V2500-A5/D5 SERIES PROPULSION SYSTEMS SERVICE BULLETIN

This document transmits the Revision 2 of Service Bulletin V2500-ENG-72-0485

V2500-ENG-72-0485

ENGINE – LP COMPRESSOR – REWORK THE INSERT HOLES OF LPC BLEED DUCT ASSEMBLY**1. Planning Information****A. Effectivity****(1) Airbus A319**

LPC Bleed Duct Assembly – Before and After Alteration
Figure 1

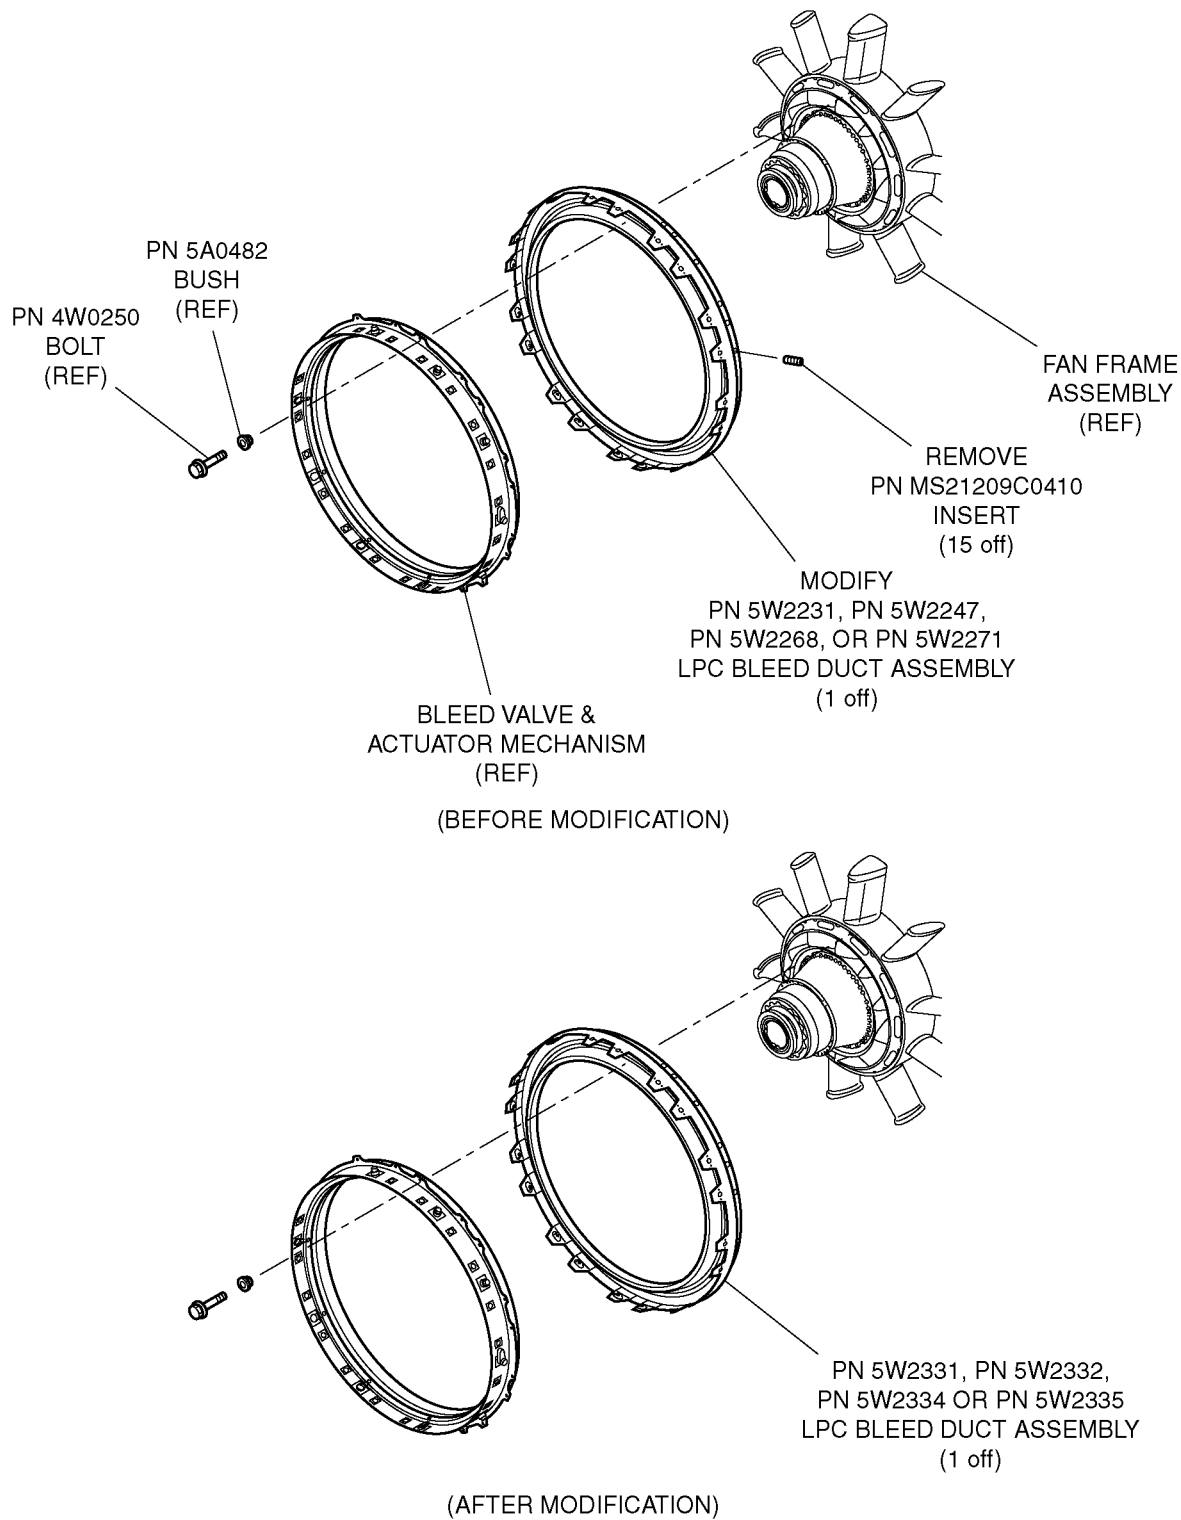
This Service Bulletin is to produce a rework instruction that shows filling the insert hole of the LPC bleed duct assembly and remarking with a new part number after the screen assemblies are removed from the LPC bleed duct assembly.

- (3) Existing LPC bleed duct assembly can be reworked to the following new part numbers.

Rework and re-identification of LPC Bleed Duct Assembly
Figure 2

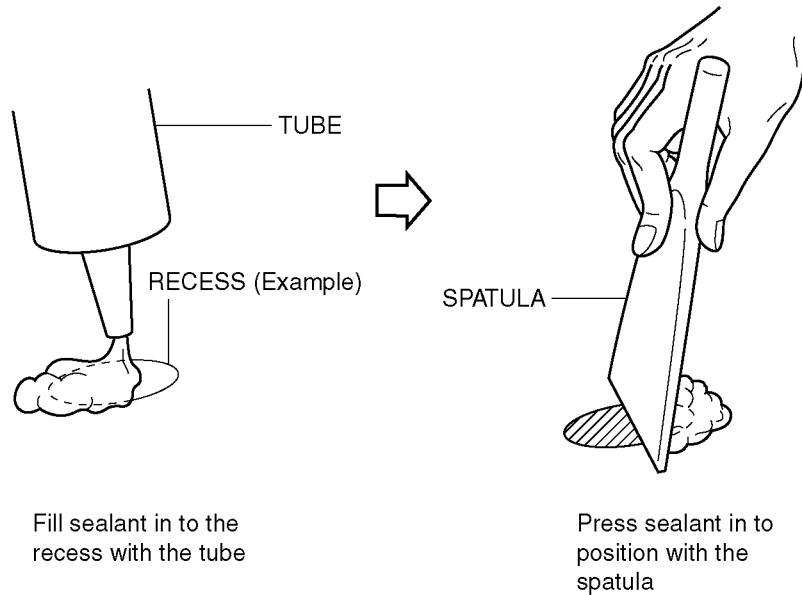
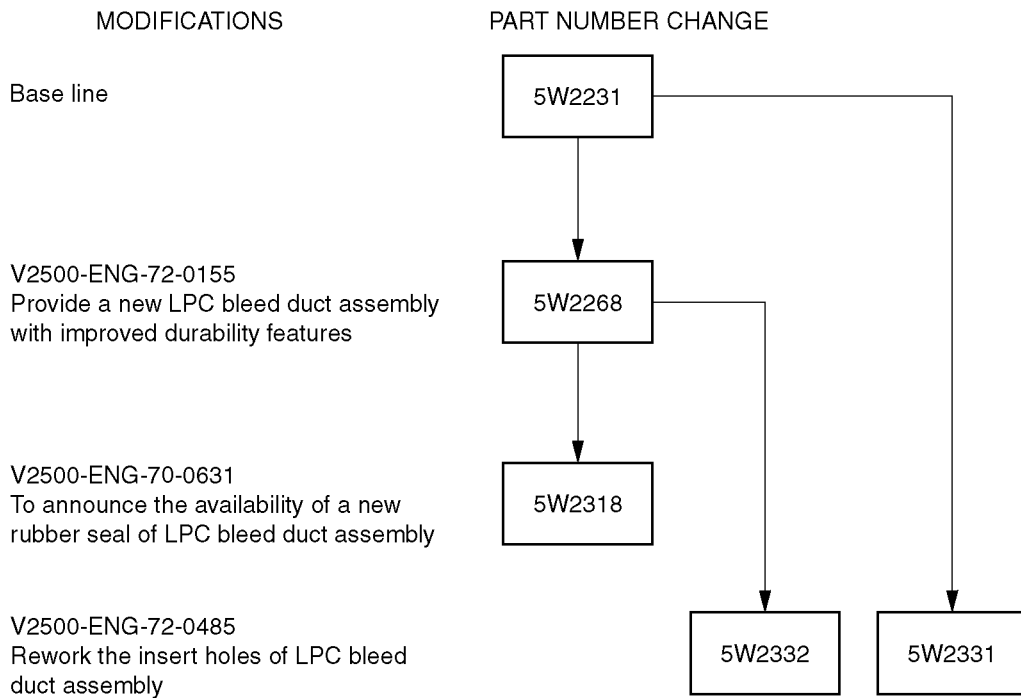
- (1) Remove the Inserts.

- (a) Remove the Helicoil inserts. Refer to TASK 70-35-08-300-501.

- (a) Apply a thin even coat of primer to the thread hole from which inserts are removed. Use CoMat 07-070 zinc chromate primer

- (b) Fill and press CoMat 08-074 sealant into the insert hole.

- (a) Vibro engrave the new part number near to the existing part number.

- (b) Cross off the existing part number with a double line.

Family Tree - LPC Bleed Duct Assembly for V2500-D5 (ATA 72-32-60, Fig-Item 01-250)
Figure 4

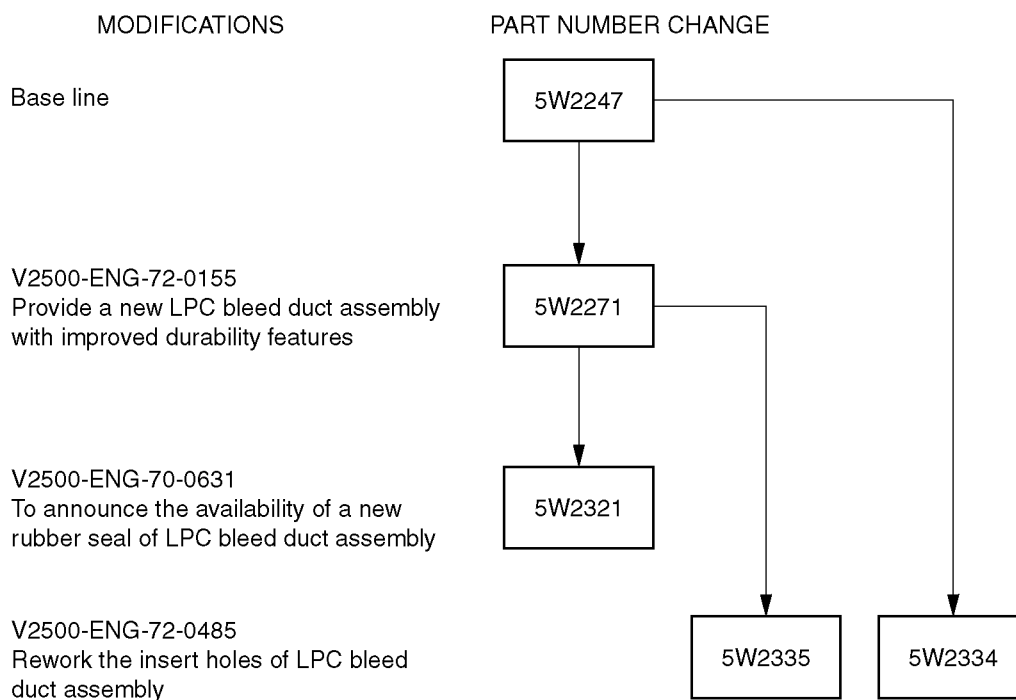
Remove	Incorporate	Reason for change
All pages of the Service Bulletin	Pages 1 to 13 of the Service Bulletin	To revise a SB reference in Figures 3 and 4.
